MVM PAKS II. ZRT.

**ERECTION OF NEW POWER PLANT UNITS AT THE
PAKS SITE**

ENVIRONMENTAL IMPACT STUDY

CLARIFICATION OF FACTS

Figure 1-1: Forecast of low water stages up to 2120 at the Paks watermark post of the Danube – including logarithmic equalisation

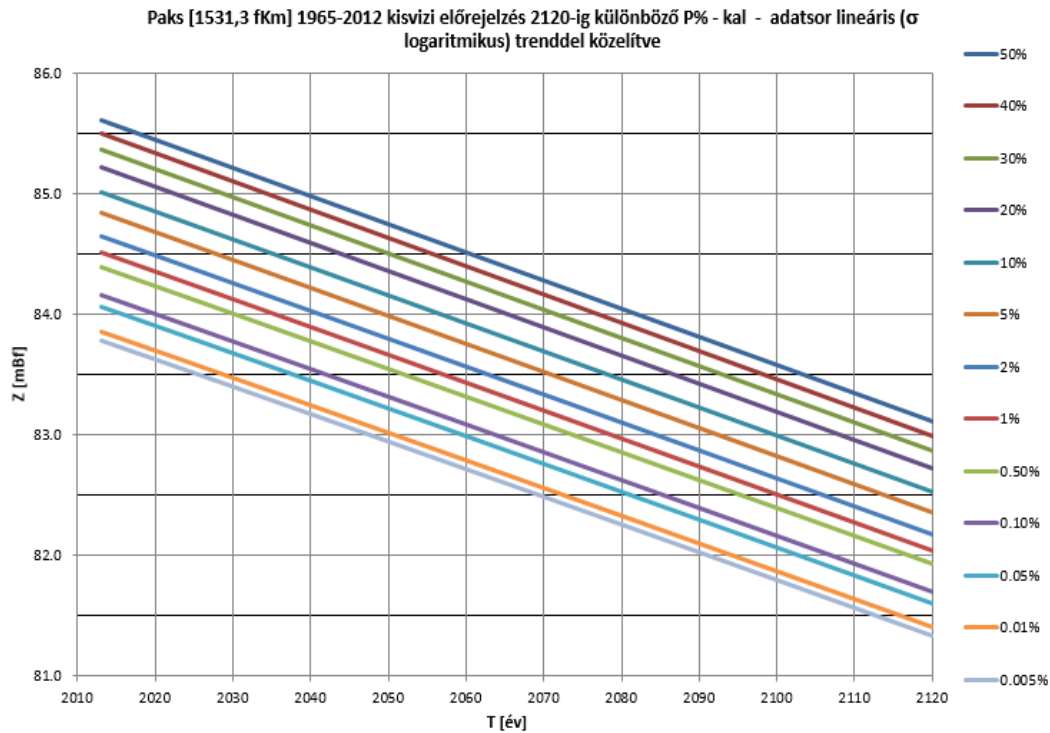
1.2 YOU ANALYSE THE RIVER BED MORPHOLOGY CHANGES OF THE DANUBE ON PAGE 101 ON THE SECTION BETWEEN 1512.0 AND 1537.3 RIVER KILOMETRES IN THE PERIOD BETWEEN 2006 AND 2013. (WITH THE USE OF A LONGER TIME SERIES THE CHANGE IN THE RATE OF RIVER BED SINKING CAN BE BETTER DEMONSTRATED AND MORE ACCURATE CONCLUSIONS CAN BE DRAWN.) THE EIS DOES NOT CONTAIN ANY FORECAST ON THE EXPECTED SINKING OF DANUBE AT THE COLD WATER CHANNEL MOUTH IN THE TO THE PERIOD BETWEEN 2015 AND 2090 AND THE IMPACT OF SUCH SINKING ON WATER EXTRACTION IS NOT EVALUATED.

Chapter 11 of the EIS contains the estimate of the expected future sinking of the Danube river bed by 2090 for the Danube cold water channel (CWC) profiles:

Fitting the low water data set (1965-2012) with logarithmic and linear trends and projected into the future the low water levels recurrent in every 20 000 years were predicted up to 2120.

In the event of a logarithmic trend (an optimistic estimate assuming complete shutdown of industrial dredging and a decaying tendency of their impacts) the 20 000 years frequency recurrence rate of low water stage was defined as 83.39 [metres above Baltic sea level] in the 1531.3 river km Danube profile. In the power plant profile this figure is 83.12 metres above Baltic sea level with a total sinking of -0.39 m, average reduction level up to 2120: -0.36 cm/year.
